**Re: DOCKET NO. 474** - The Connecticut Light & Power Company d/b/a Eversource Energy application for a Certificate of Environmental Compatibility and Public Need for the Greater Hartford-Central Connecticut Reliability Project that traverses the municipalities of Hartford, West Hartford, and Newington, which consists of (a) construction, maintenance and operation of a new 115-kilovolt (kV) electric transmission line within existing Eversource, Amtrak and public road rights-of-way and associated facilities extending overhead approximately 2.4 miles and underground approximately 1.3 miles between Eversource's existing Newington Substation in the Town of Newington and existing Southwest Hartford Substation in the City of Hartford; (b) modifications to a .01 mile section within existing Eversource right-of-way of the existing overhead 115-kV electric transmission line connection to the Newington Substation (Newington Tap); and (c) related modifications to Newington Substation and Southwest Hartford Substation.

***Re: Docket No. 474: The Connecticut Light & Power Company d/b/a Eversource Energy application for a Certificate of Environmental Compatibility and Public Need for the Great

TOWN OF WEST HARTFORD  
54,529 (NEW) BRITAIN AVE. AT SOUTH ST. AND PRIVATE DRIVE  
REV # 18 INTERSECTION # 155-226

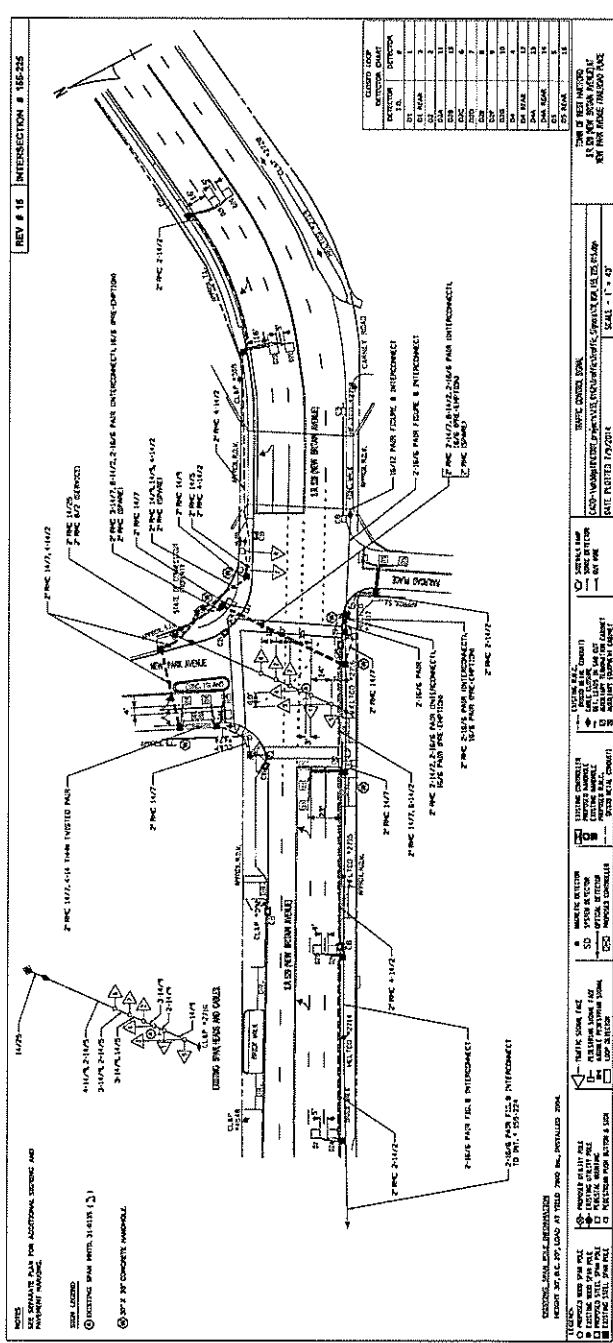
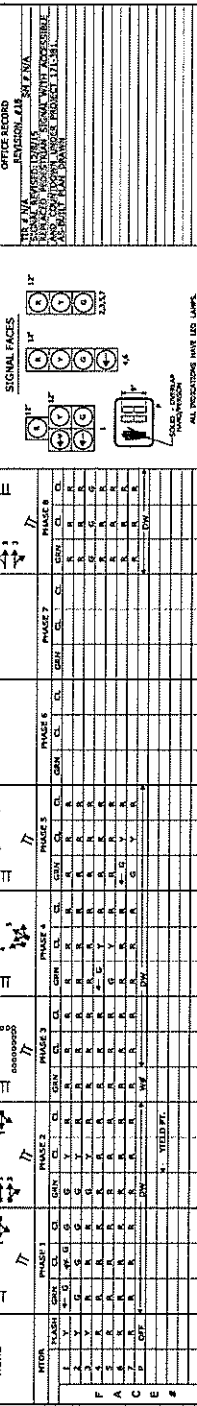
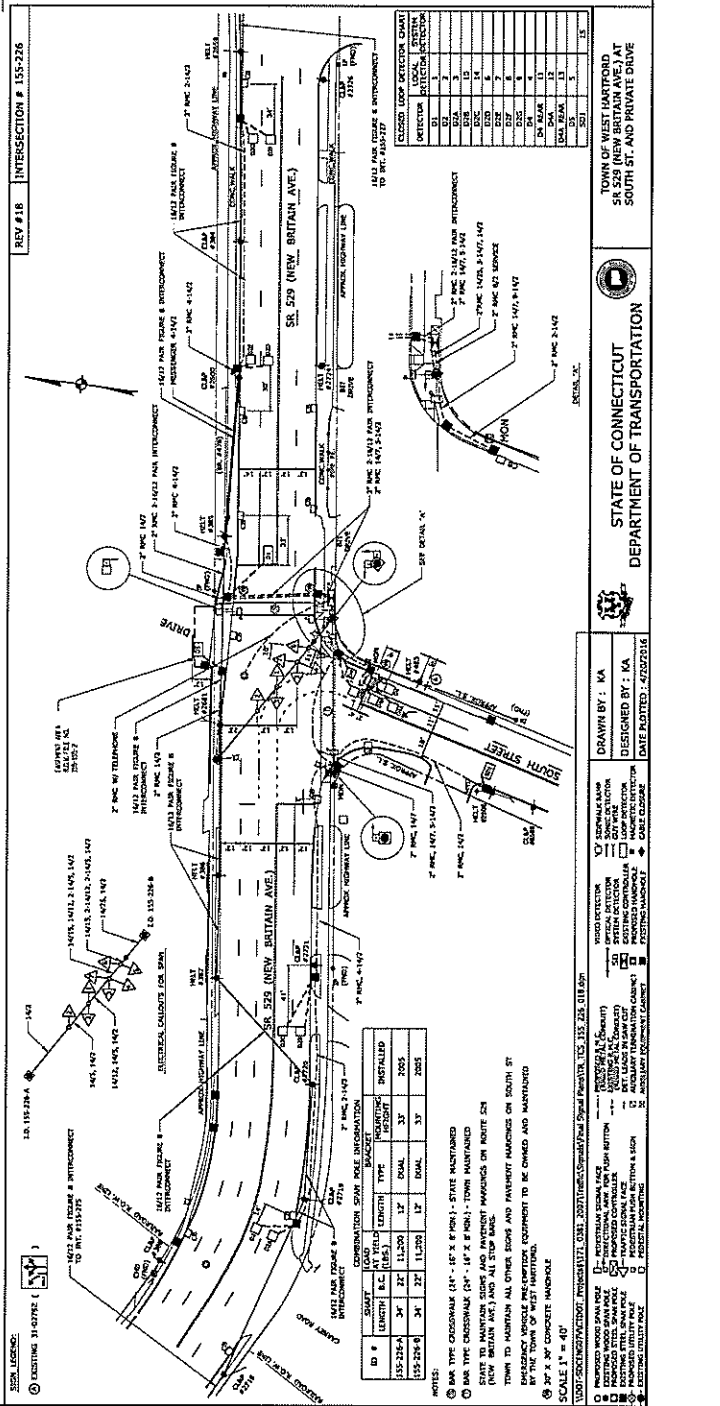
8. Enclosed are signal plans for the two signalized intersections (Intersection Nos. 155-225 and 155-226) in proximity to the proposed overhead crossing of SR 529 (New Britain Avenue) in West Hartford. These signals are part of a closed loop signal system and have a hard wire interconnect between them. It appears this interconnect is underground between CL&P Nos. 2717 and 2718. The interconnect is overhead to the east of CL&P No. 2718. Eversource should insure the interconnect facility is protected from damage during Route construction.

8. Enclosed are signal plans for the two signalized intersections (Intersection Nos. 155-225 and 155-226) in proximity to the proposed overhead crossing of SR 529 (New Britain Avenue) in West Hartford. These signals are part of a closed loop signal system and have a hard wire interconnect between them. It appears this interconnect is underground between CL&P Nos. 2717 and 2718. The interconnect is overhead to the east of CL&P No. 2718. Eversource should insure the interconnect facility is protected from damage during Route construction.

**Eversource will insure the interconnect facility is protected from damage during construction.**
